STAFF REPORT: 12/14/2022 REGULAR MEETING

APPLICATION NUMBER: #22-8159

ADDRESS: 4762 CORTLAND

SCOPE: ALTER ROOF, REPLACE ROOFING (WORK DONE WITHOUT APPROVAL), INSTALL VINYL WINDOWS AND FRONT DOOR

Site Photo 1, by Staff November.23, 2022: (South) front elevation.

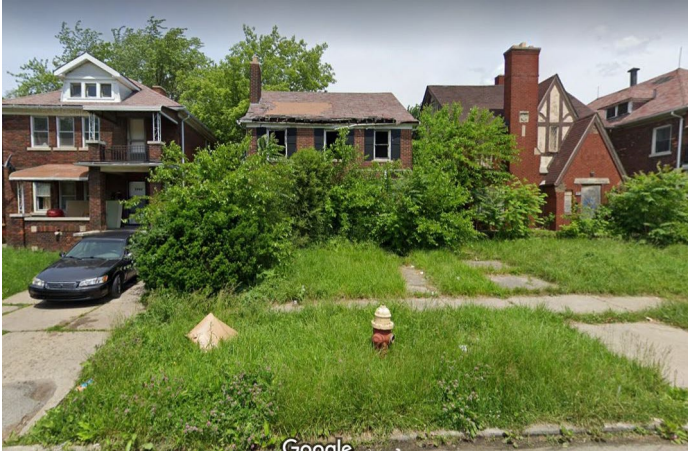
- Staff received confirmation that the wood panels below the front, first floor windows are no longer present and the sidelights on either side of the front door are still present. Both are currently covered in plywood and not visible. (*See photos 1 & 4*)
